Director of Nuclear Reactor Regulation  
Attention: Mr. B. J. Youngblood, Chief  
Licensing Branch No. 1  
Division of Licensing  
U. S. Nuclear Regulatory Commission  
Washington, D. C. 20555

Subject: Emergency Preparedness Plans for the Fermi-2 Facility

DETROIT EDISON'S  
RESPONSES  
TO  
MONROE COUNTY  
ASSERTIONS

FIGURE 1  
10-MILE EMERGENCY PLANNING ZONE --  
FERMI 2

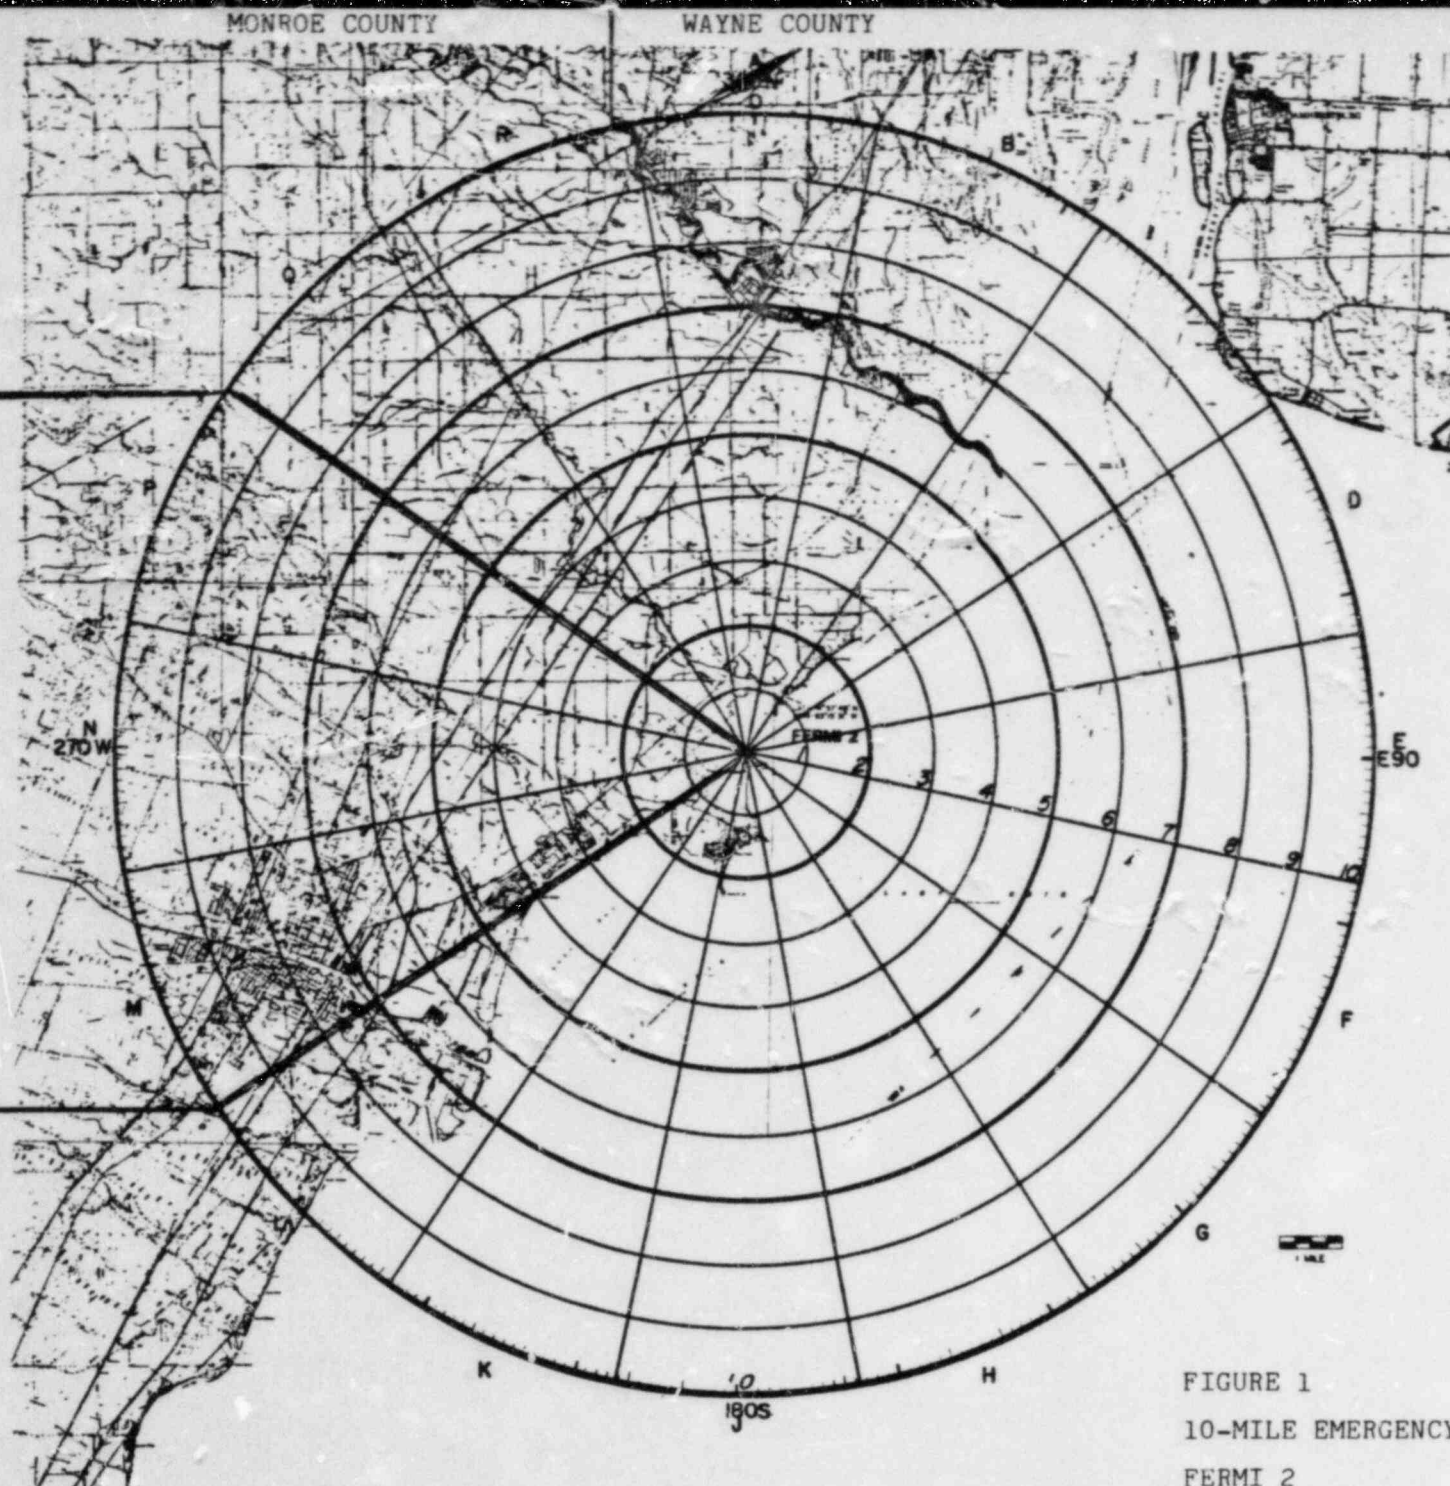
THE COUNTY LACKS THE BUS CAPACITY TO EVACUATE PEOPLE WHO ARE WITHOUT TRANSPORTATION.

In an evacuation of the 10-mile MPA, available bus capacity is 129 percent of the requirements. This indicates that all population without automobiles could be evacuated in a single run of the available bus fleet.

Figure 4.2.1 Selective Evacuation Subareas

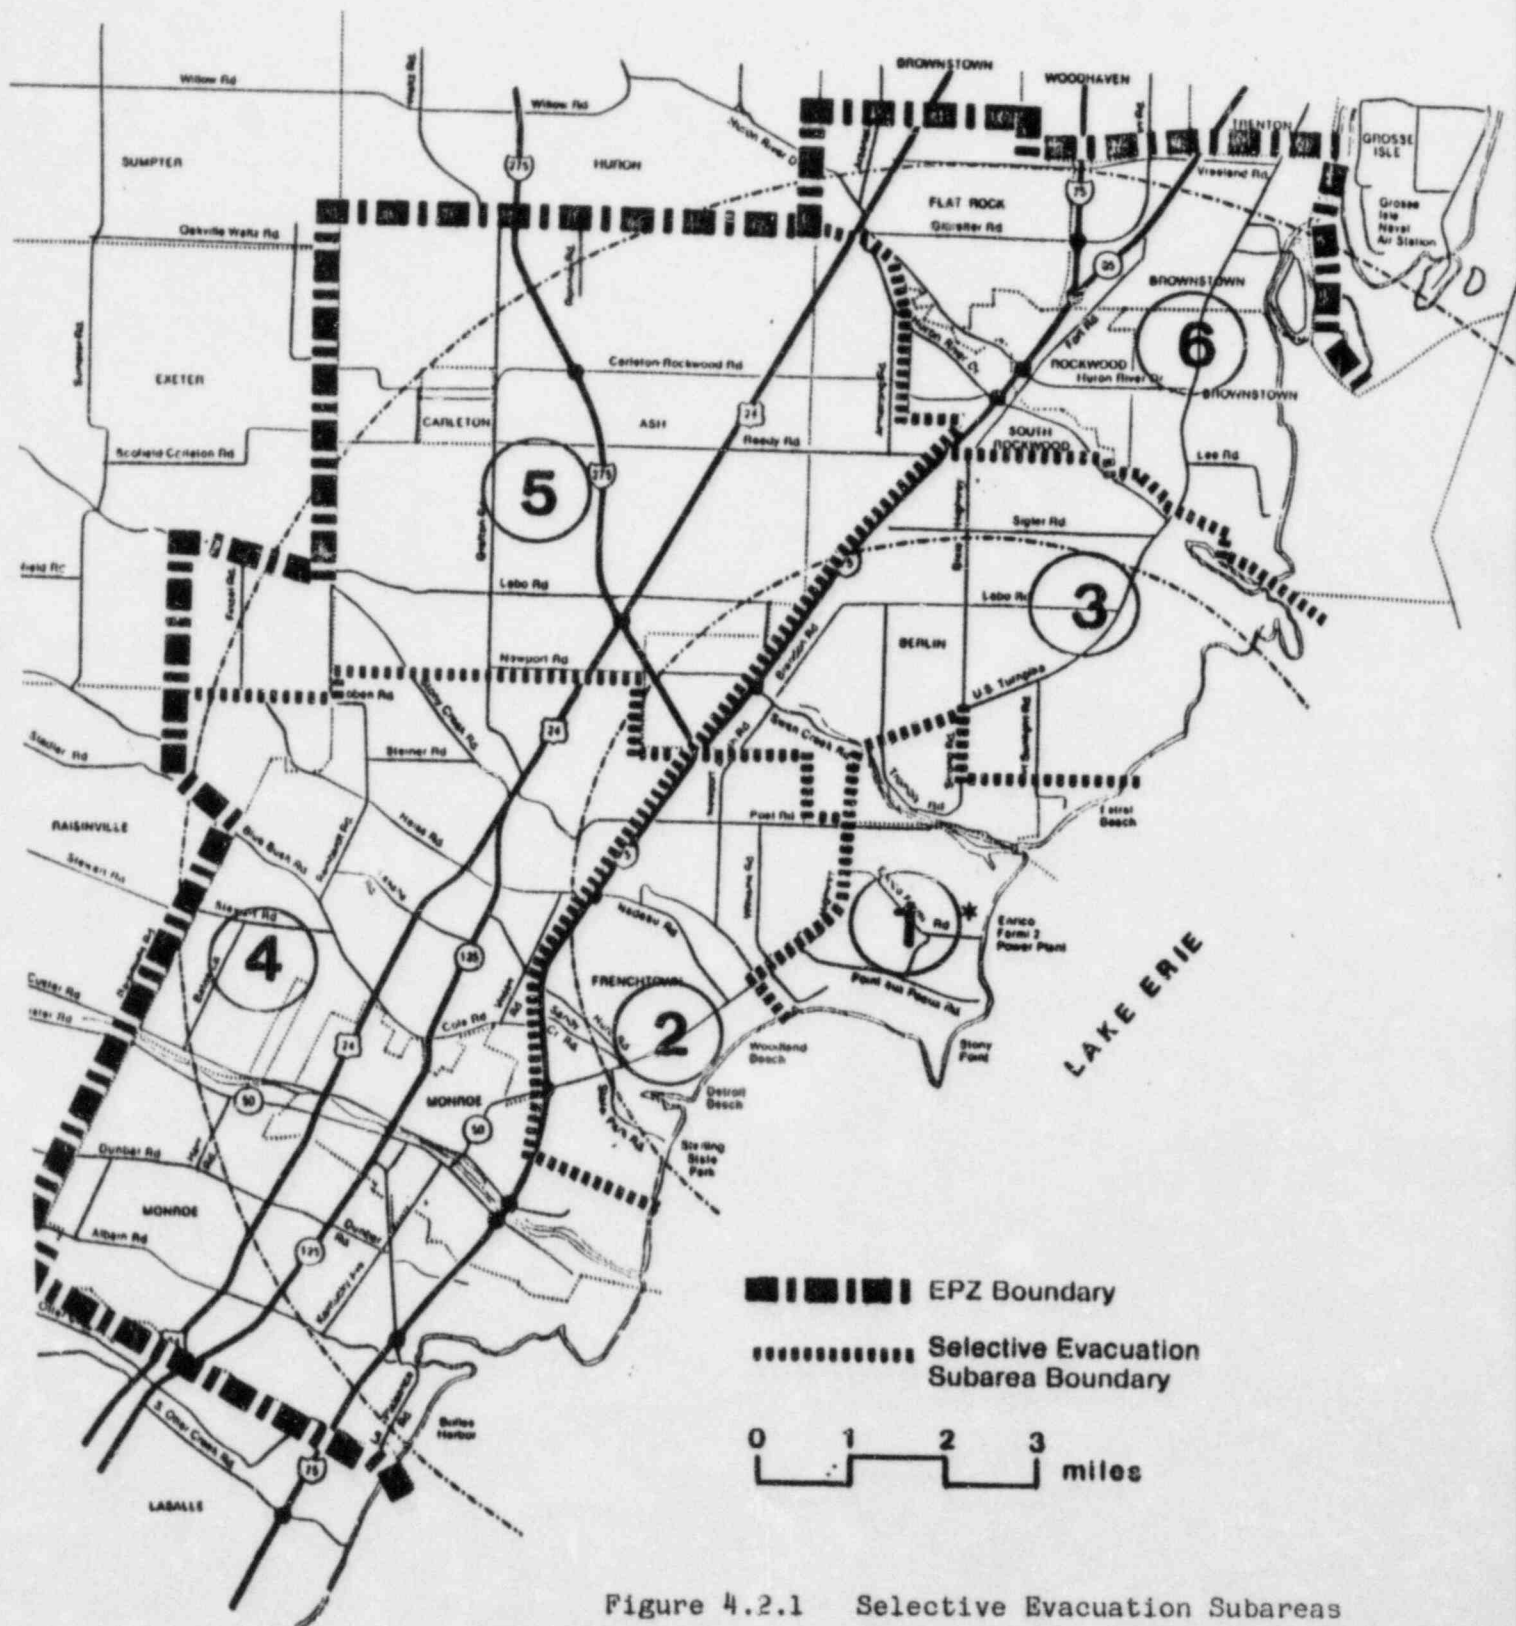
THE COUNTY QUESTIONS WHETHER AN EVACUATION CAN BE SUCCESSFULLY ACCOMPLISHED, GIVEN THE LENGTH OF TIME NEEDED TO MOBILIZE COMMAND OFFICIALS, THE INADEQUACY OF EXISTING ROADS, AND THE FREQUENT IMPASSABILITY OF THE ROADS IN WINTER.

Under normal weather conditions, the evacuation of all automobile traffic from the 10-mile EPZ, as shown in Figure 4.2.1, can be accomplished in 4 hours. Route-by-route evacuation times, ranging from 2 hours 40 minutes to the maximum of 4 hours, are summarized in Table 4.2.1.
